# **IAEA INTERNATIONAL PEER REVIEW MISSION ON MID-AND-LONG-TERM ROADMAP TOWARDS THE DECOMMISSIONING OF TEPCO'S FUKUSHIMA DAIICHI NUCLEAR POWER STATION UNITS 1-4 (Third Mission)**

**Tokyo and Fukushima Prefecture, Japan  
9 – 17 February 2015**

**MISSION REPORT TO  
THE GOVERNMENT OF JAPAN**

**Issue Date:** 13 May 2015

FIG. 2. Contaminated water treatment and storage scheme.

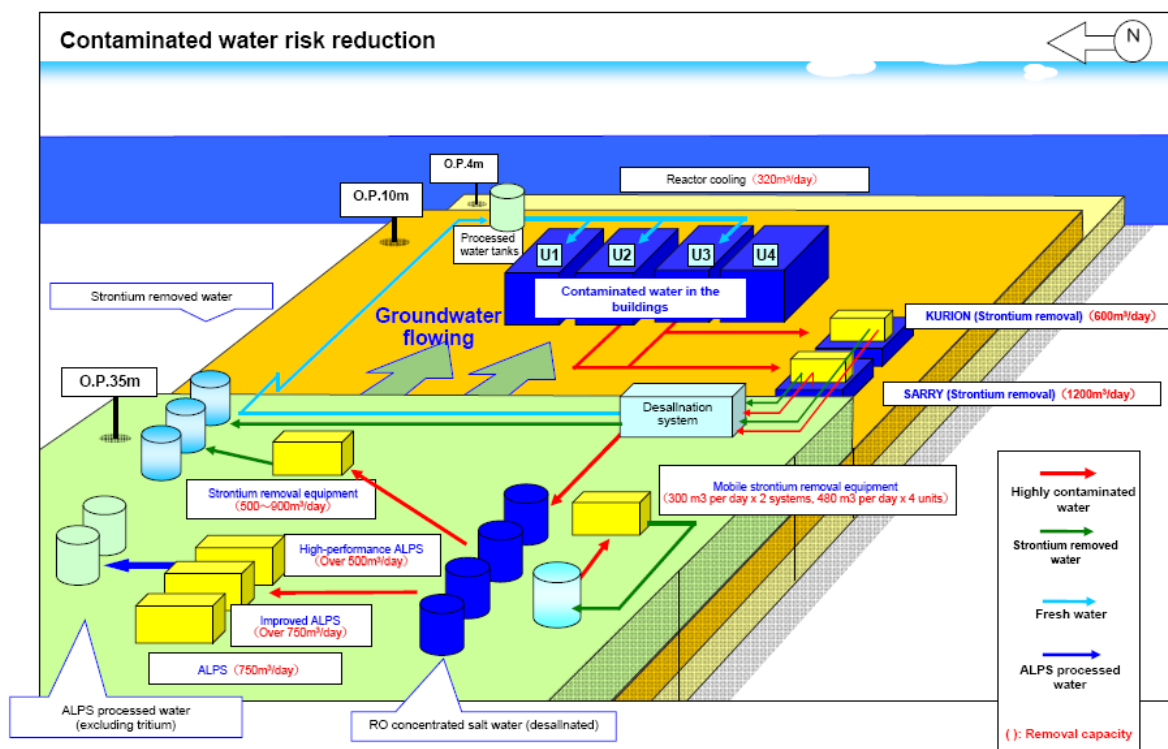
Whilst acknowledging TEPCO's efforts to reduce the risk of storing large volumes of highly radioactive water by removing strontium and other radionuclides as quickly as possible, the IAEA team believes waste minimization should also be an important consideration in such efforts.

Each new piece of equipment adds to the radioactive waste to be managed, and several more items are planned for installation. The IAEA team was informed that this was done because available treatment capacity was not sufficient to meet target deadlines. For example, the actual operating capacity of the three ALPS systems has been only 1200 m<sup>3</sup>/day as compared to their full design capacity of 2000 m<sup>3</sup>/day. Discussions during the mission indicate that this shortfall may be related to the complexity of the treatment flow sheets and the use of newly developed selective sorbents being industrially deployed for the first time. There is, for example, a need for frequent cleaning or replacement of the cross flow filters in the first two ALPS systems, resulting in significant downtime. Lower than expected service life of strontium sorbent in the high performance ALPS system is another example. Obviously, fine-tuning operating conditions and achieving performance targets for these systems is taking more time than initially estimated. TEPCO needs to resolve these issues promptly and optimize the various processes.
